Ruhe Subdivision

Minor Plan 2013-201

Memorandum

SUBJECT: Ruhe Subdivision
Minor Plan 2013-201
PRELIMINARY/FINAL PLAN REVIEW

BY	DATE
MSN	06/16/2021
MSN	12/16/2021
IMK	09/20/2023
IMK	11/17/2023

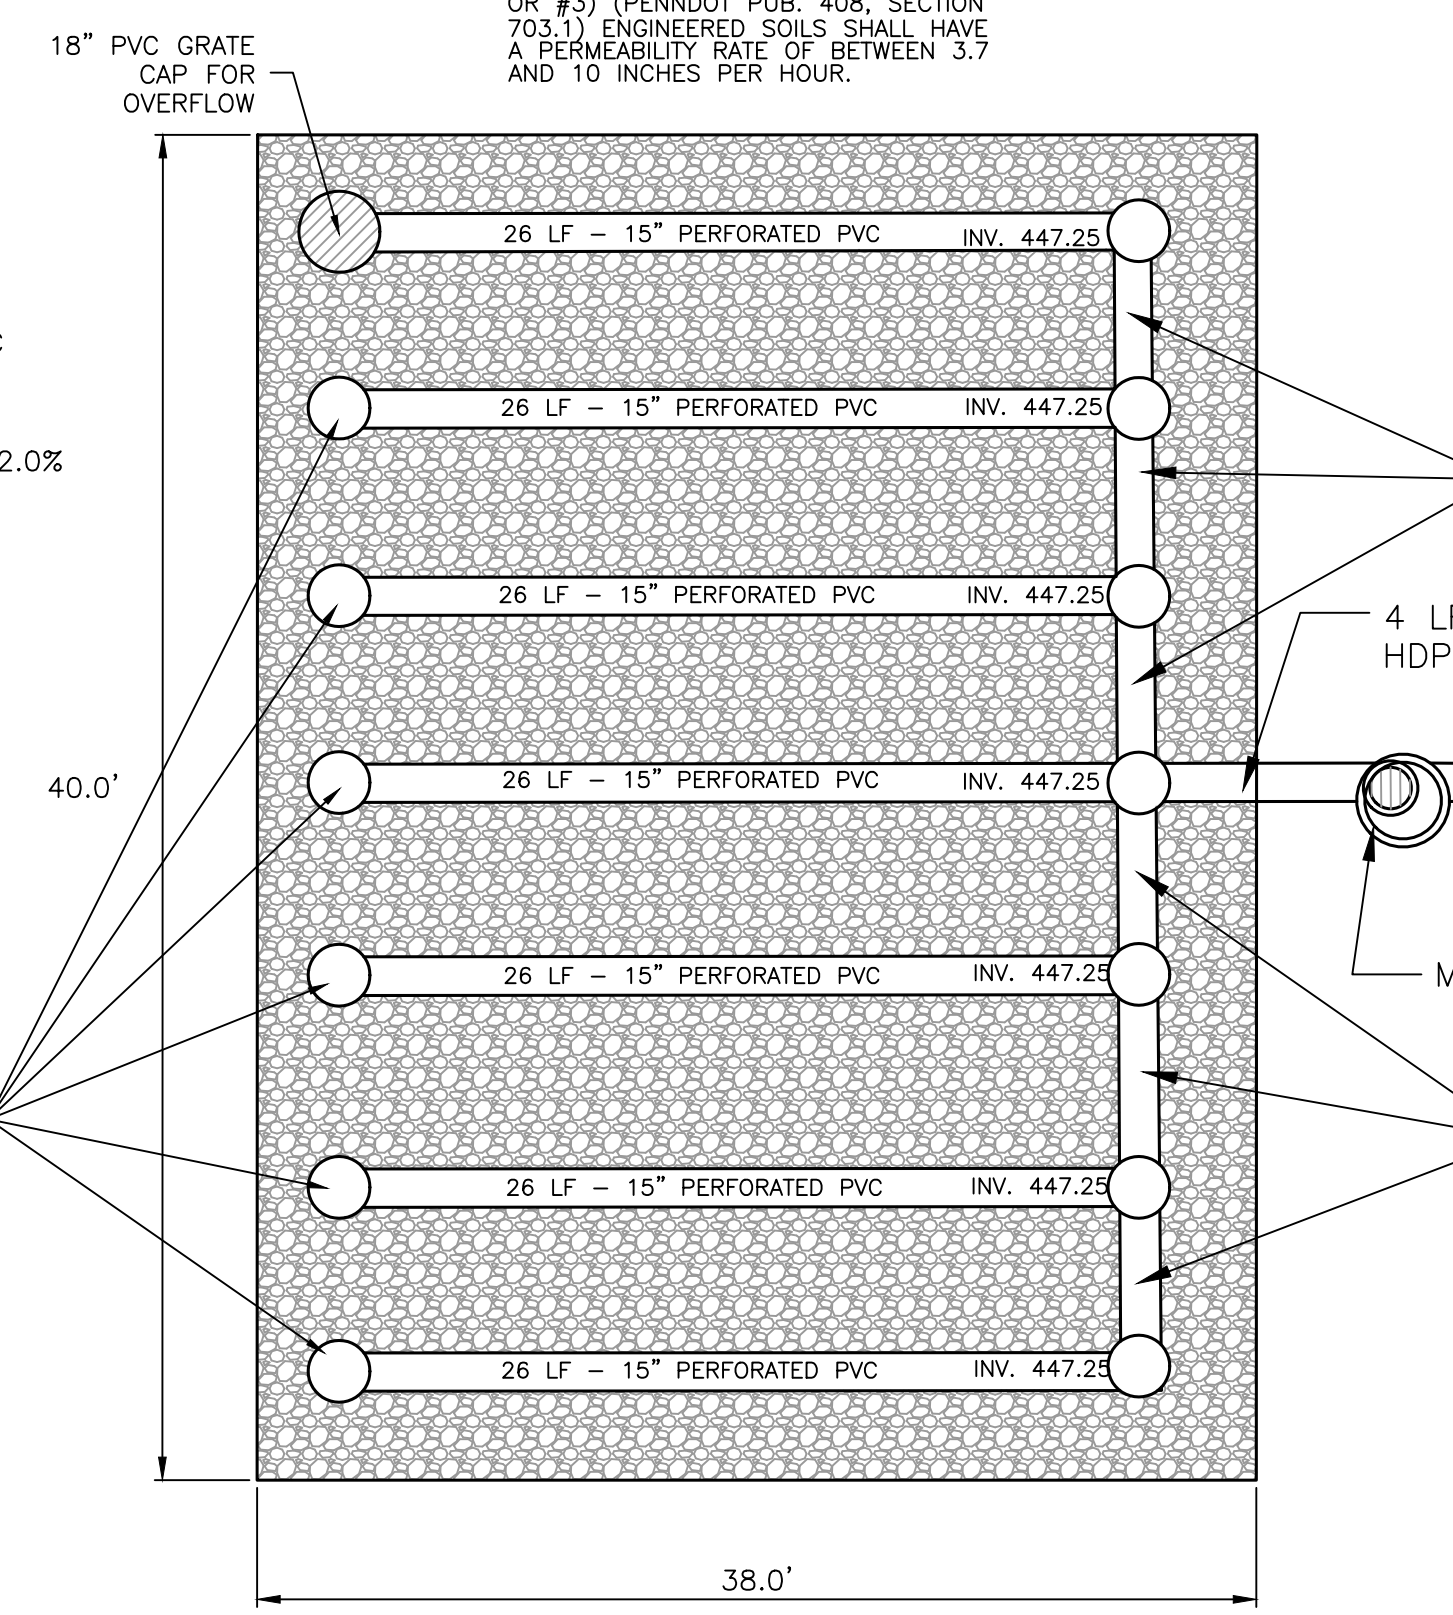
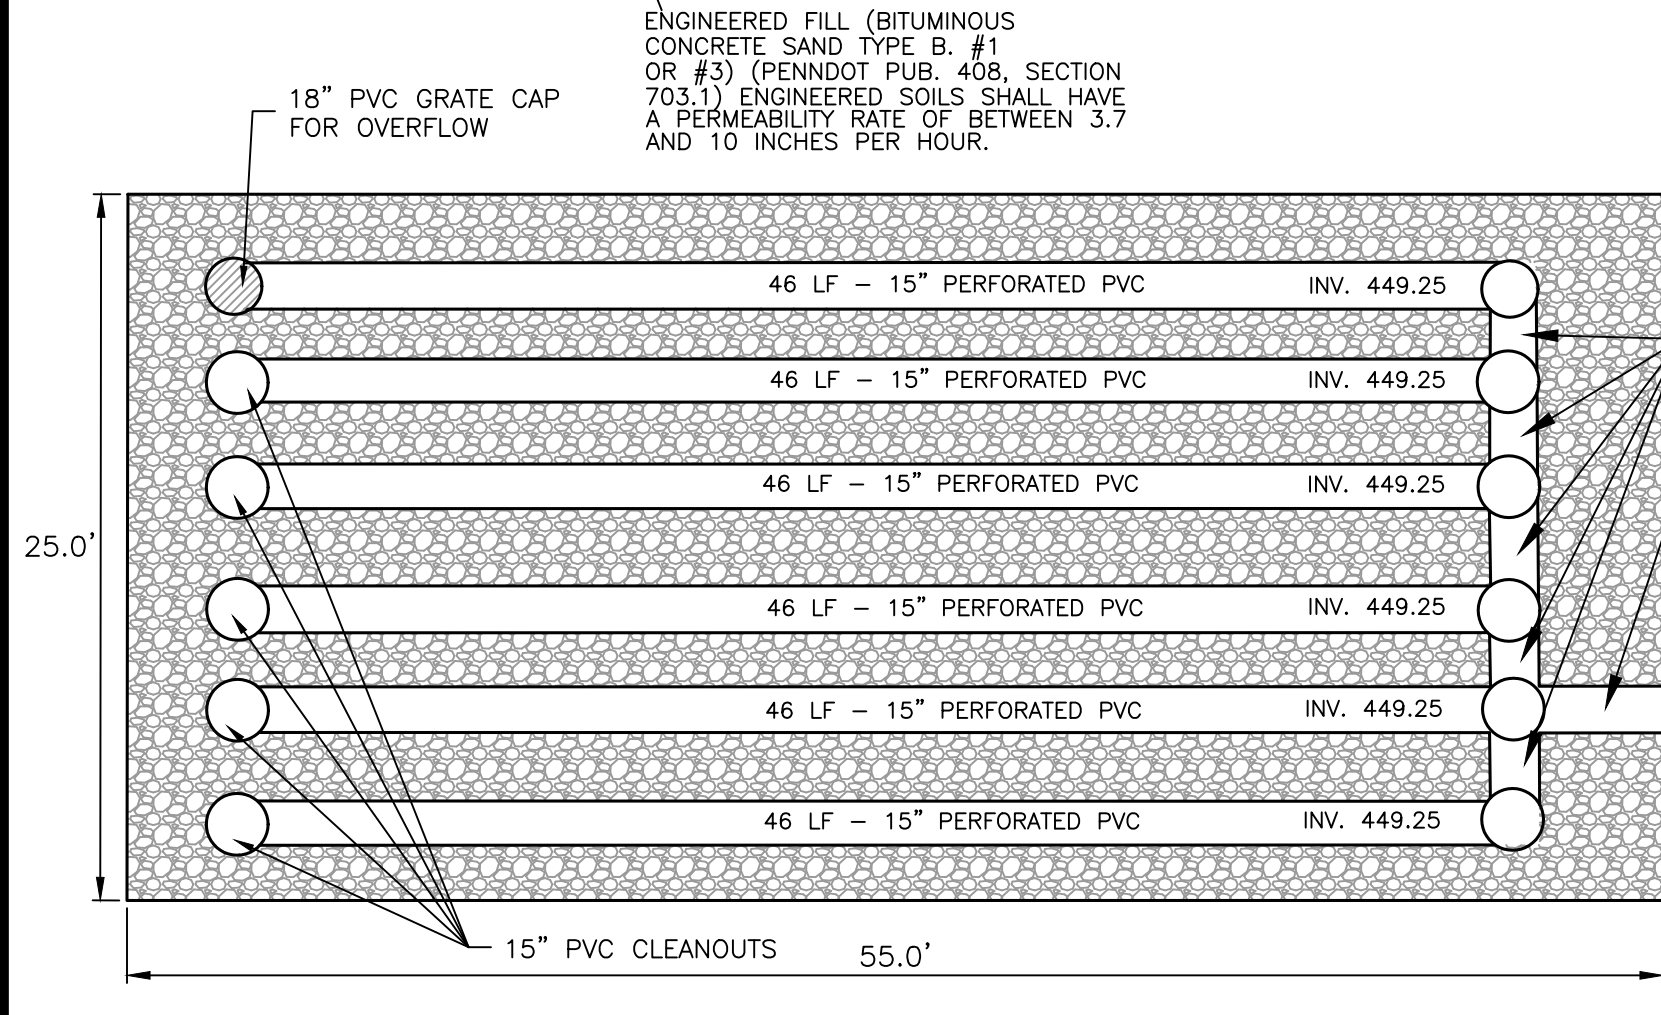
3. **Utilities Details: Sheet 16 of 23:**

STORMWATER DETAILS
RUIHE MINOR SUBDIVISION
PRELIMINARY/FINAL PLAN
 2442 HUCKLEBERRY ROAD
 SOUTH WHITEHALL TOWNSHIP
 LEHIGH COUNTY, PENNSYLVANIA

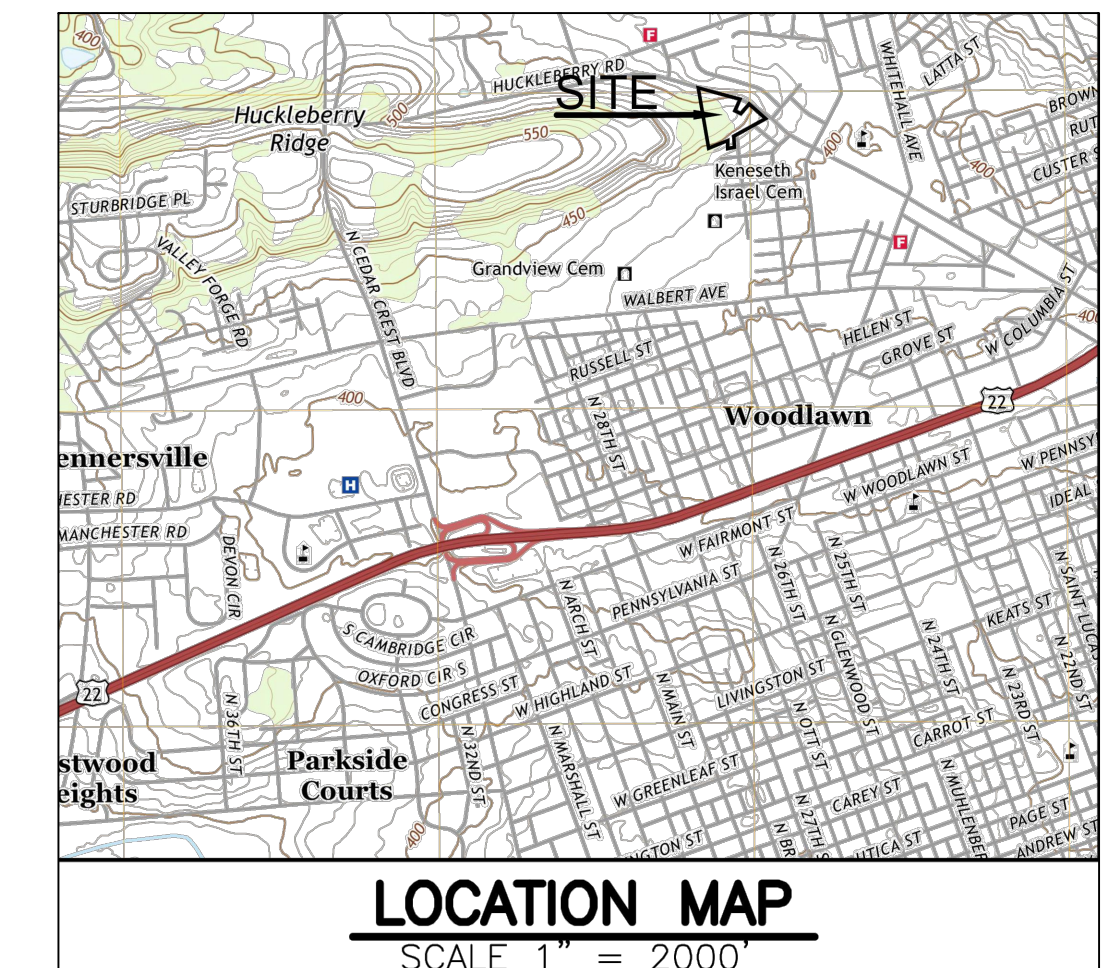
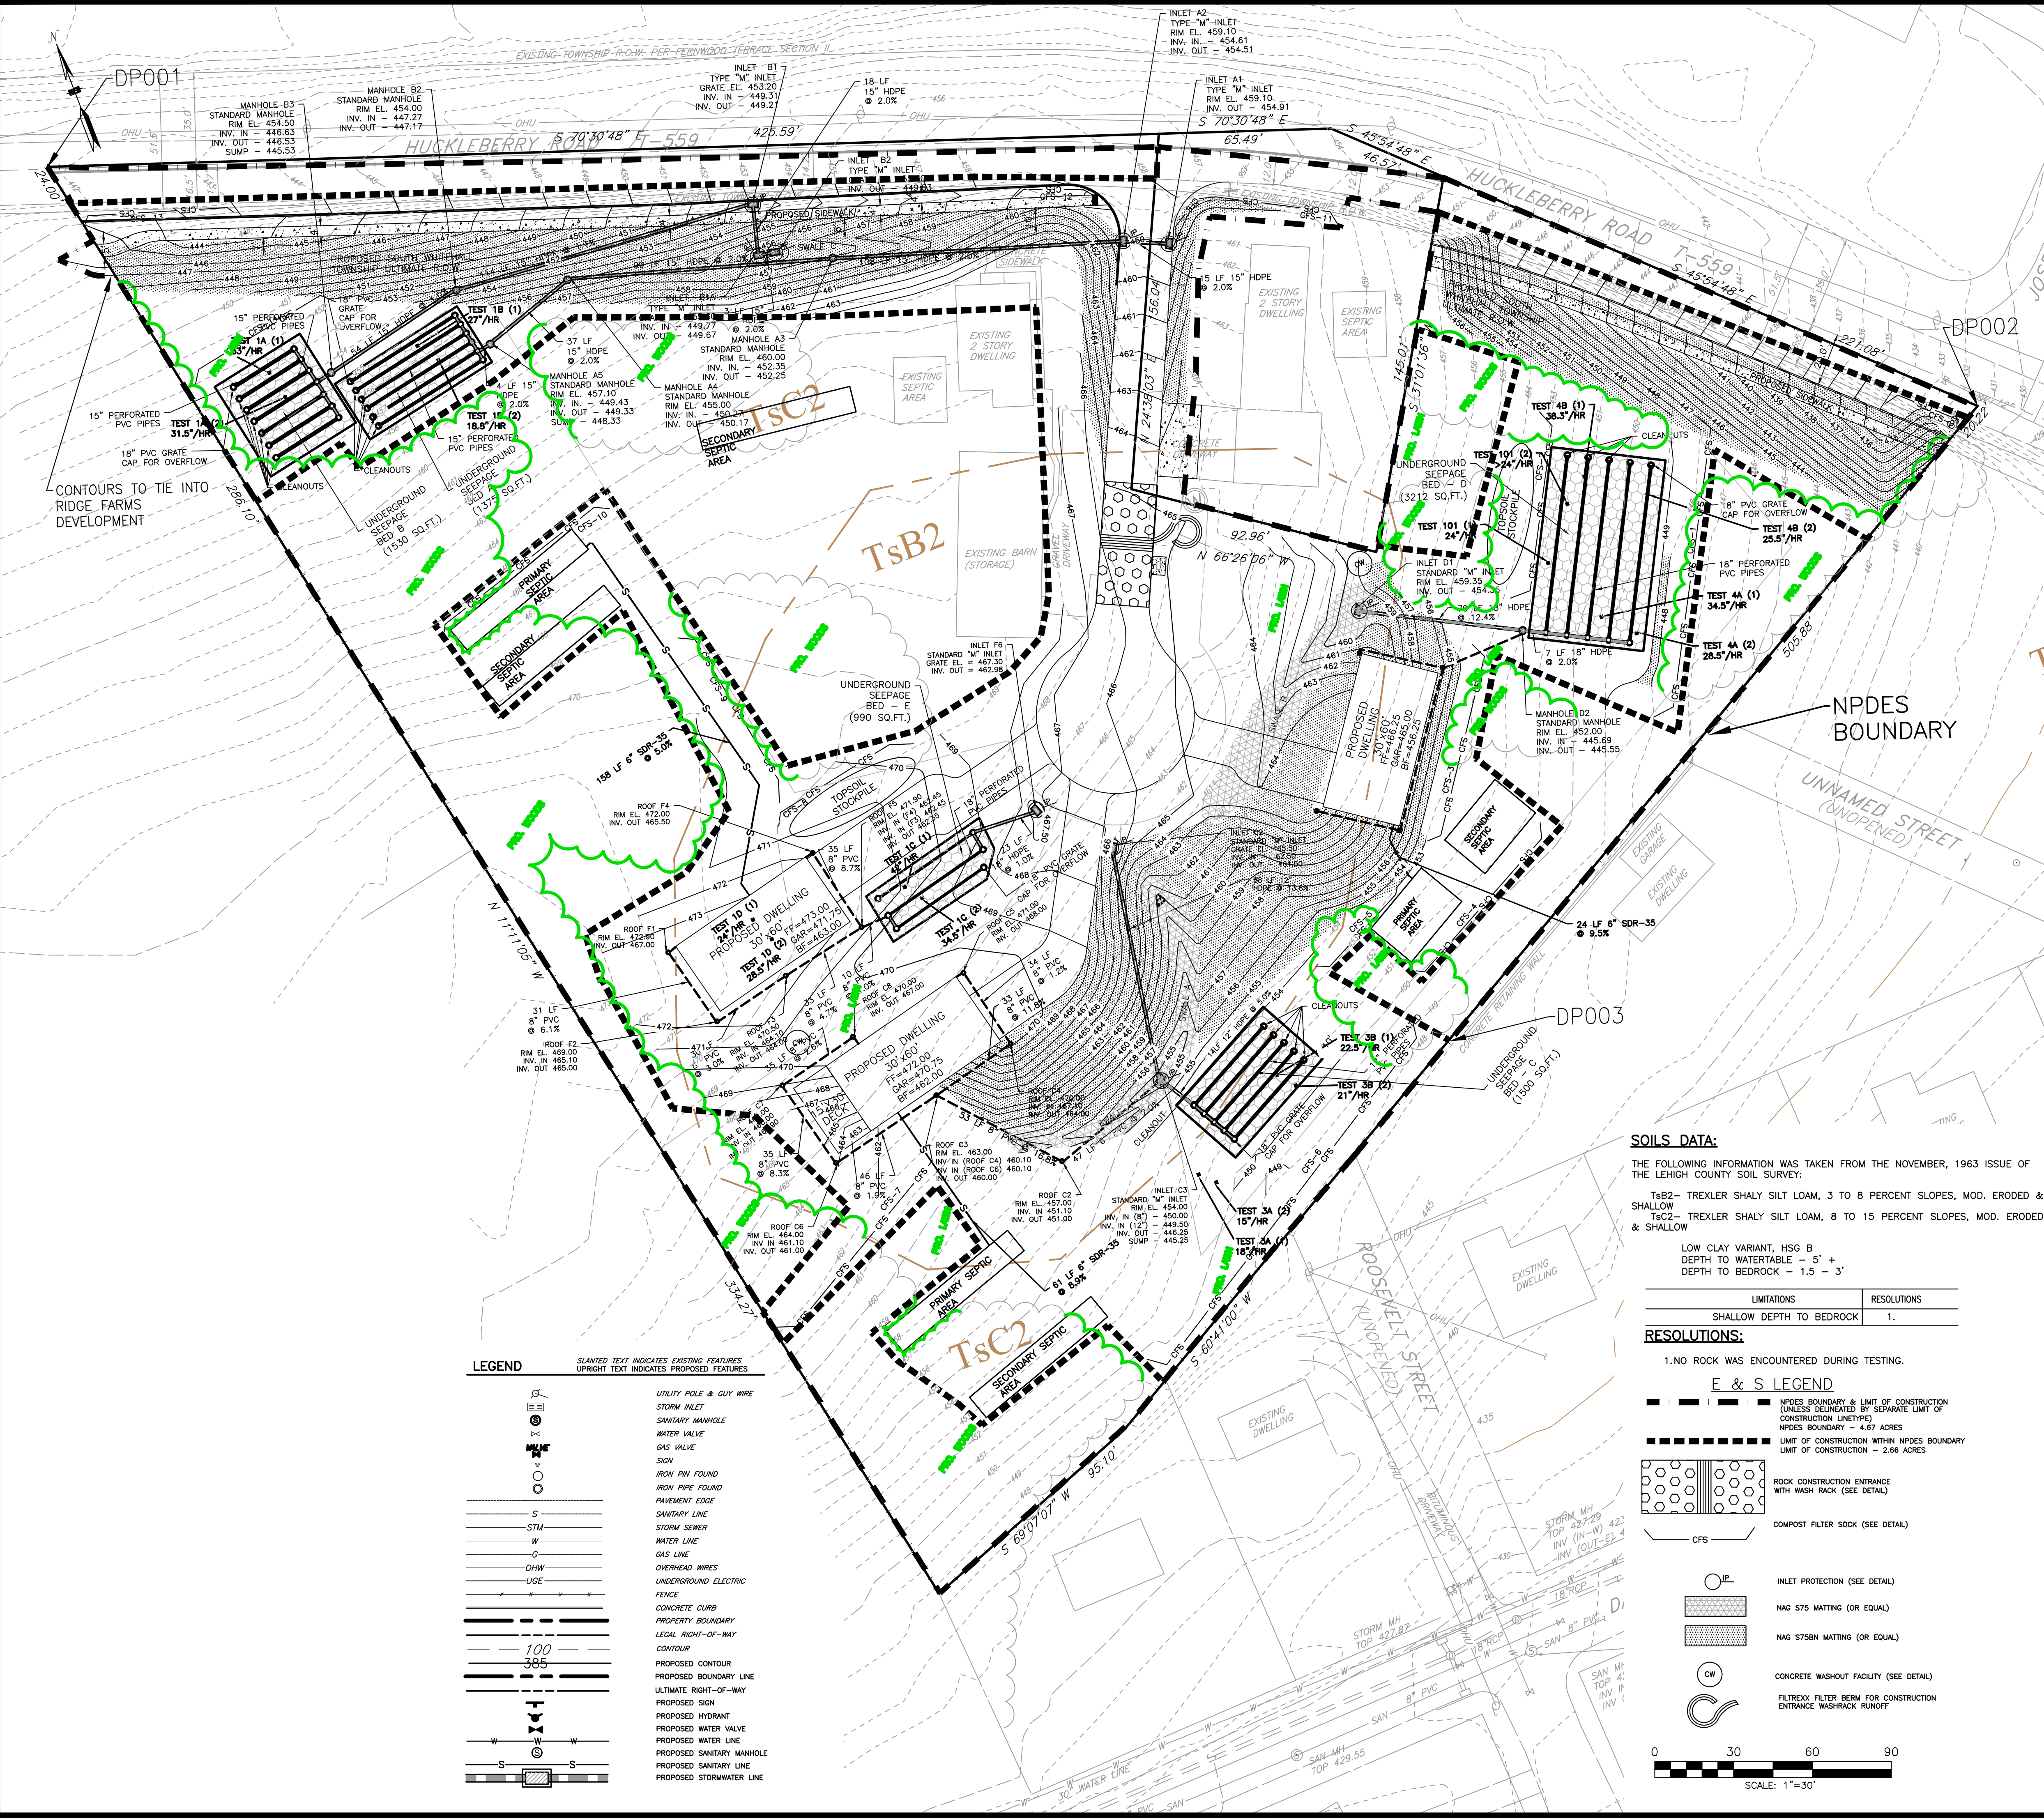
- 1. *The specifications contained in the Erosion & Sediment Control Narrative, Sequence of BMP Construction, Item 6E, and in plan notes on Sheet 17 appear to indicate the placement of geotextile on the bottom of each infiltration bed subgrade, below the engineered fill. This should be indicated clearly on the infiltration bed cross sections by revising the label to read "Wrap all sides and bottom of basin" or by other notes/ labeling.*

1. The specifications contained in the Erosion & Sediment Control Narrative, Sequence of BMP Construction, Item 6E, and in plan notes on Sheet 17 appear to indicate the placement of geotextile on the bottom of each infiltration bed subgrade, below the engineered fill. This should be indicated clearly on the infiltration bed cross sections by revising the label to read "Wrap all sides and bottom of basin" or by other notes/labeling.
